SOUTHERN SEA FARMS LTD
MAHIMAHI PILOT PLANT
SANDALWOOD BAY

Report and Recommendations
of the
Environmental Protection Authority

Bulletin 304

November 1987

Figure 2. Cross Section of Proposed Pilot Plant
 (from Southern Seas Farms Ltd)

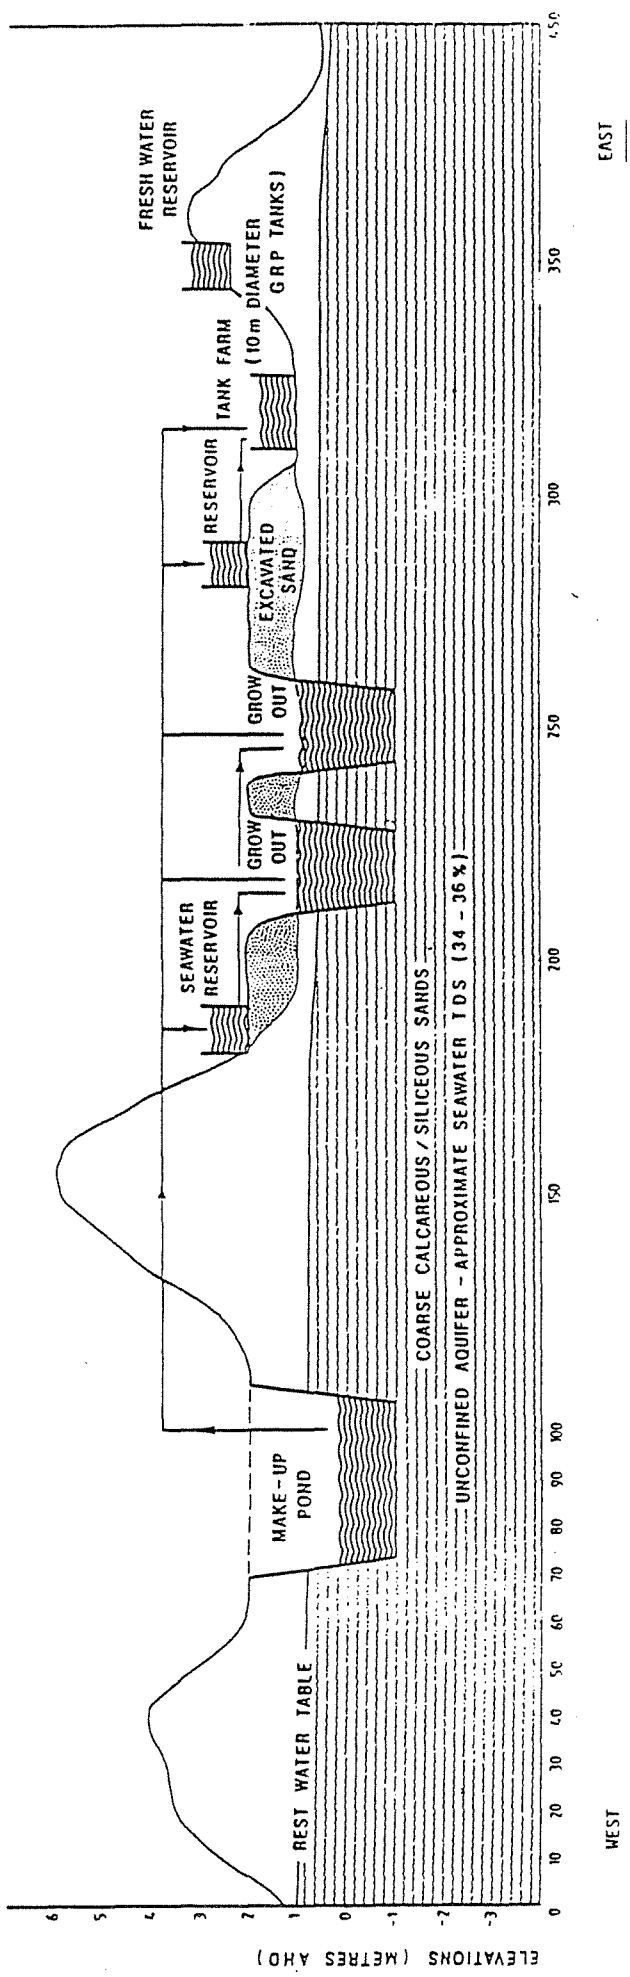
It is proposed to test four types of fish holding facilities: conventional 10 metre diameter fibreglass tanks which would be set on sandpads in the area; shallow unlined ponds, of various shapes and sizes, excavated into the water table in the same manner as the make-up water trench; vinyl lined ponds; and concrete tanks (see Figures 2 and 3).
